World Forum for Harmonization of Vehicle Regulations (WP.29)

DRAFT SUPPLEMENT 24 TO THE 03 SERIES OF AMENDMENTS
TO REGULATION No. 37

(Filament lamps)

The drawing of filament shape No. 3, correct to read (replace by new drawing):

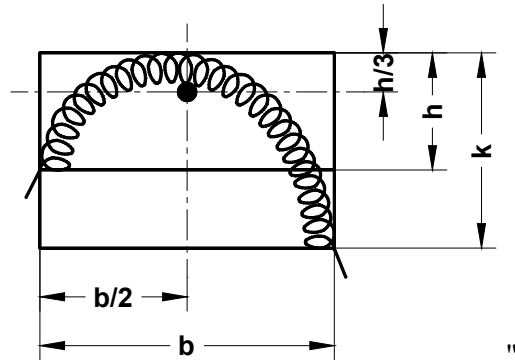
Add at the end of the text, to read:

" intersection of the dash-dot lines.

The drawings are intended only to demonstrate the essential dimensions."

Sheet H8/1

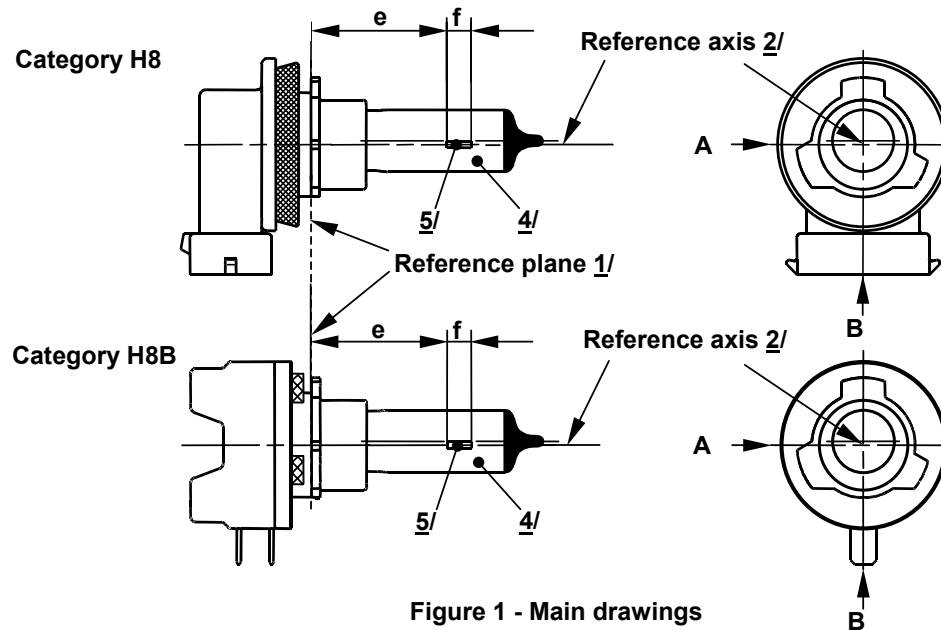
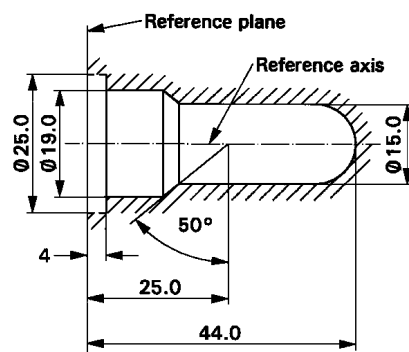
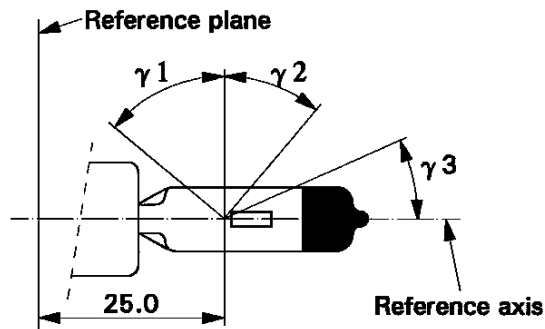
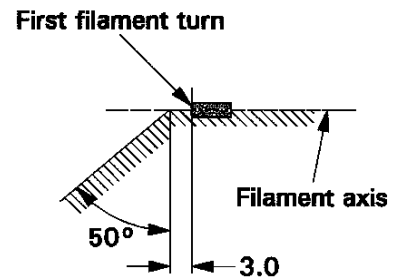
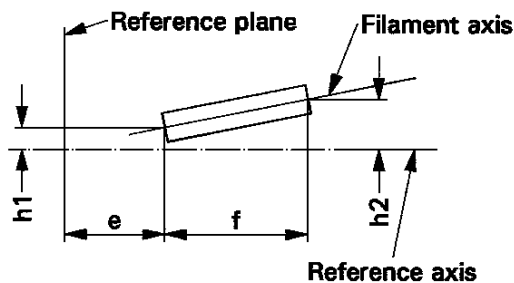
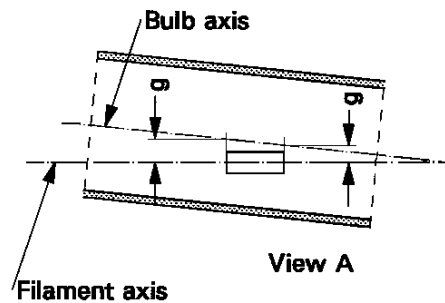
Sheets H8/1 to 4, replace by new sheets H8/1 to 4; (see next pages).

Sheet H9/1

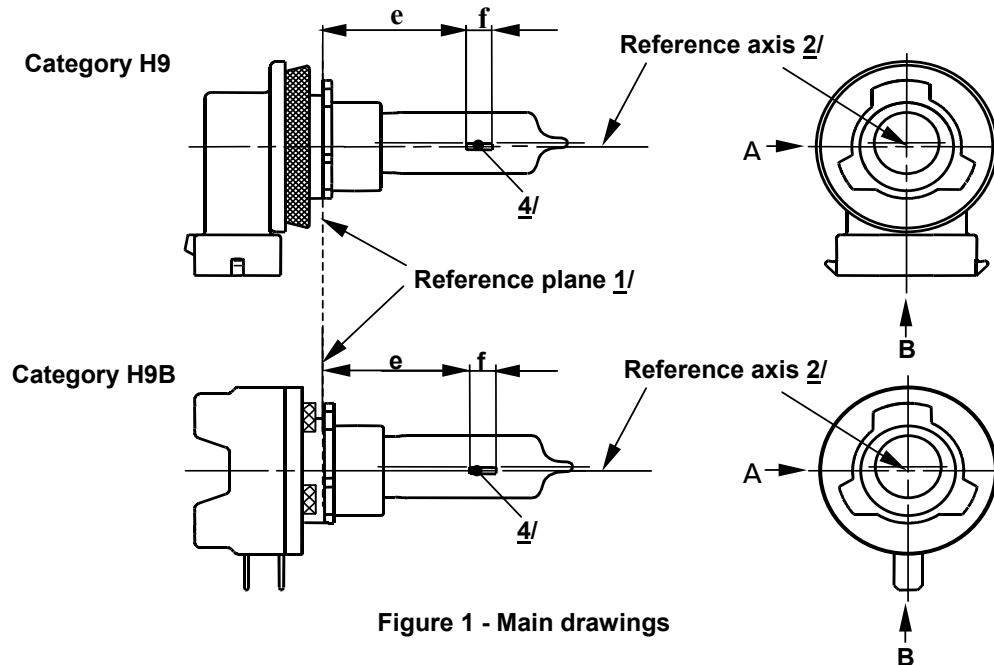
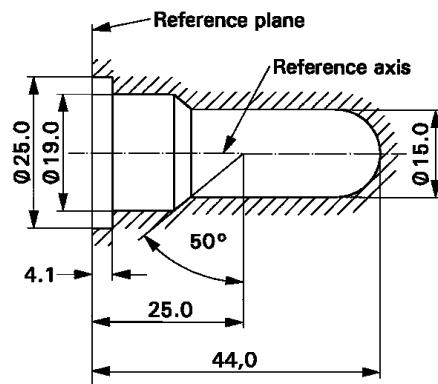
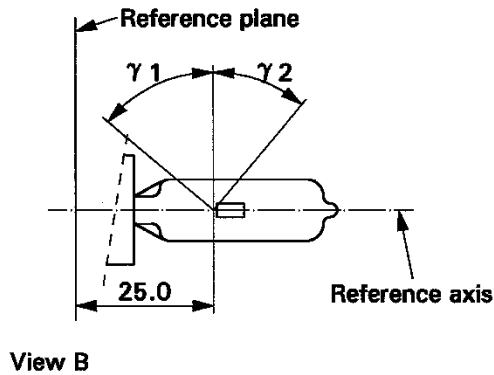
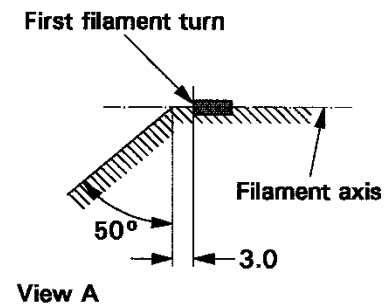
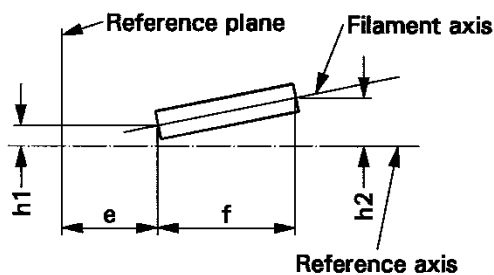
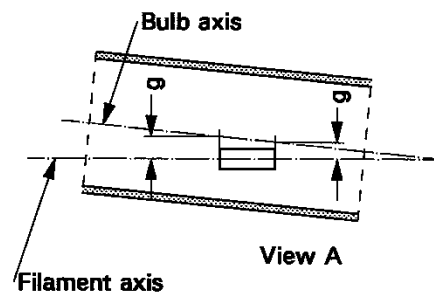
Sheets H9/1 to 4, replace by new sheets H9/1 to 4; (see next pages).

Sheet H11/1

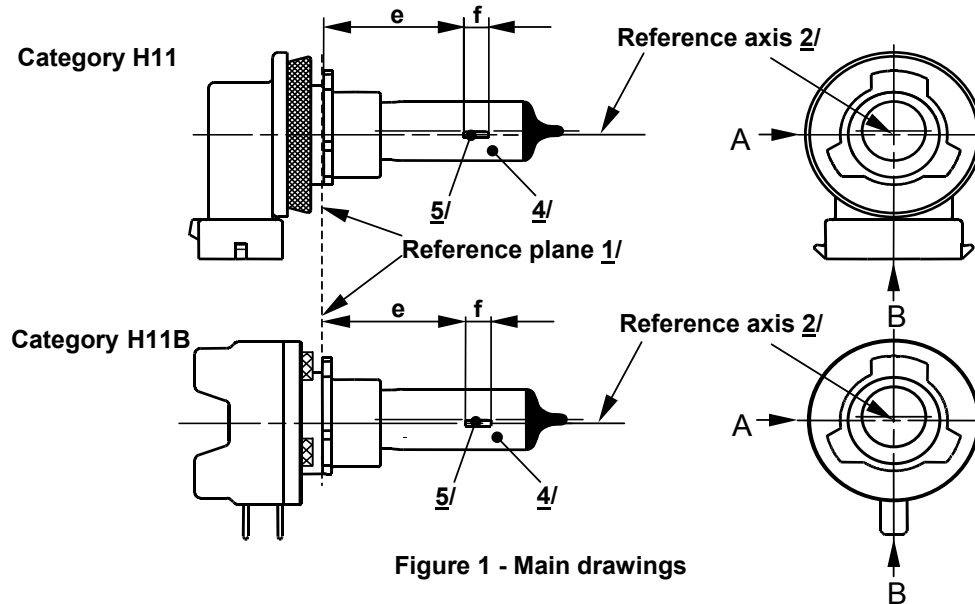
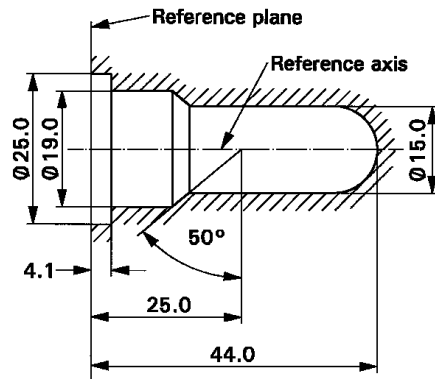
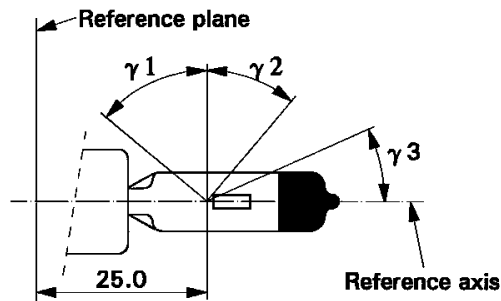
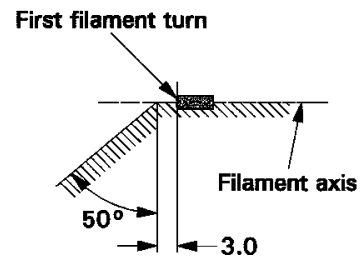
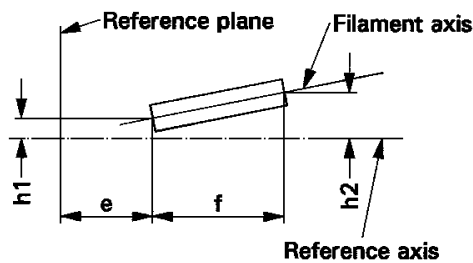
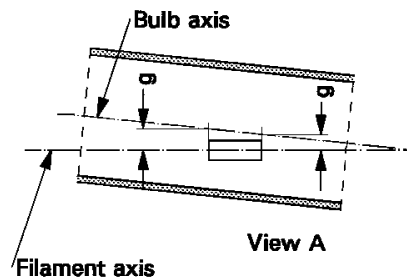
Sheets H11/1 to 4, replace by new sheets H11/1 to 4; (see next pages).

Sheet HIR2/1

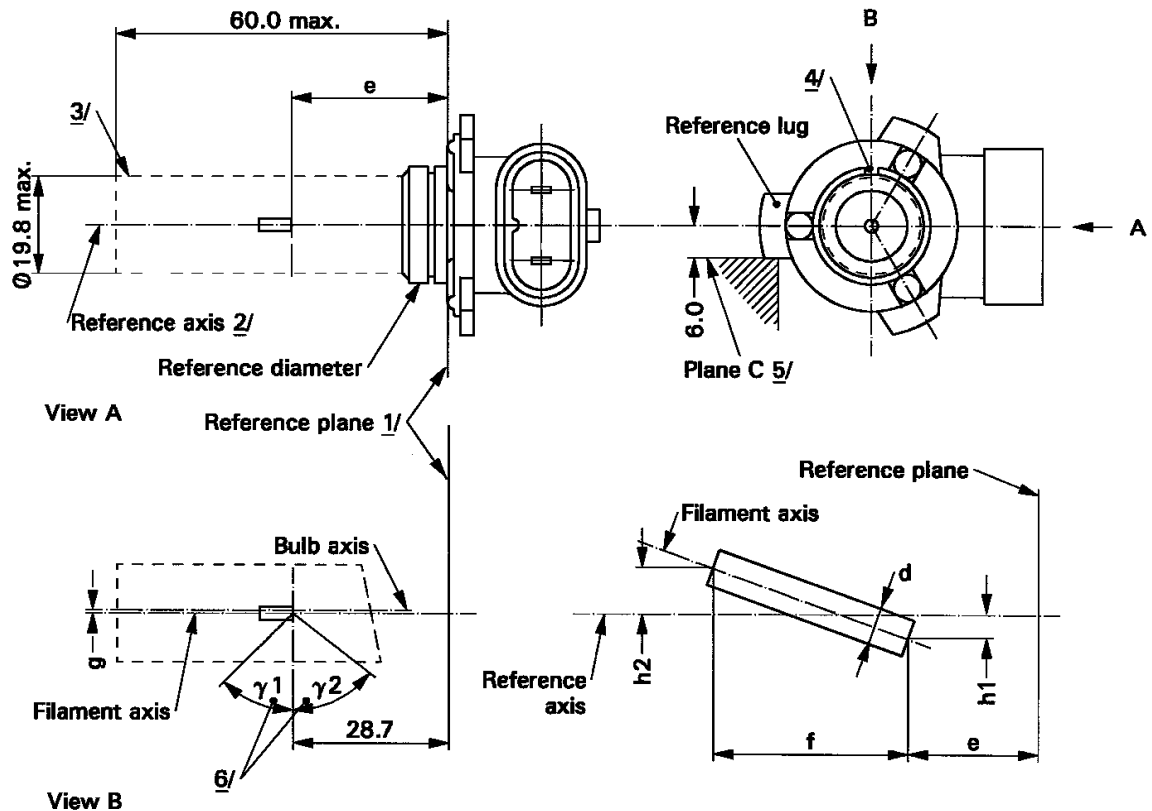
Sheets HIR2/1 to 3, replace by the new sheets HIR2/1 to 3; (see next pages)

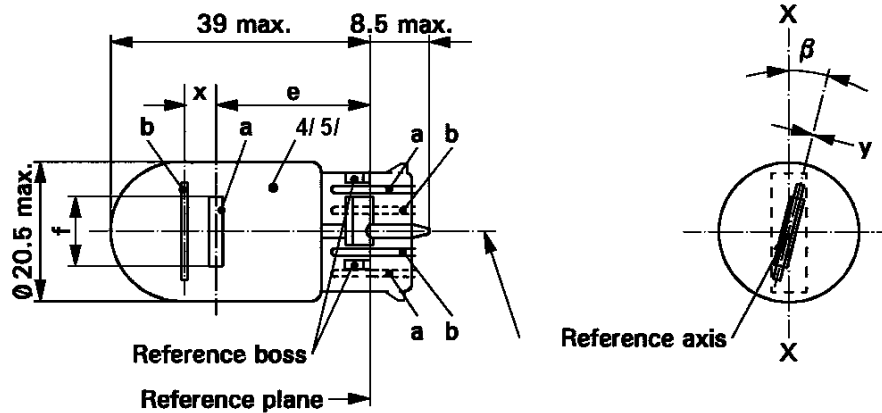
Insert new sheet WR21/5W/1 (between sheet WP21W/2 and sheet WY2.3W/1 as indicated in the list of sheets above), to read: (see next pages).
